Whirl Wind Propellers Corporation
1800 Joe Crosson Dr., El Cajon, CA 92020
619-562-3725

SERVICE LETTER

SL-400C-020624

SUBJECT: REPLACEMENT OF MCCAULEY COUNTERWEIGHTS ON ALL 400 SERIES PROPELLERS.

Figure 3

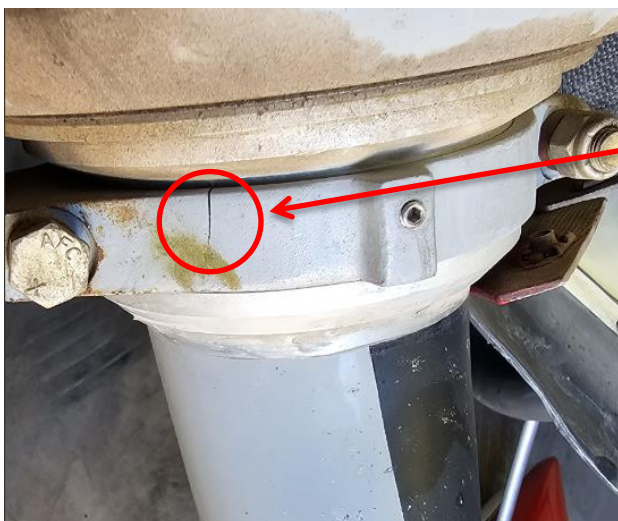
Clean and inspect Counterweight Clamps with 10X Magnifying glass for possible cracks.

If cracks are found, the propeller is not airworthy. (DO NOT FLY)

If no cracks are found, replace counterweights within the next 5 flight hours.
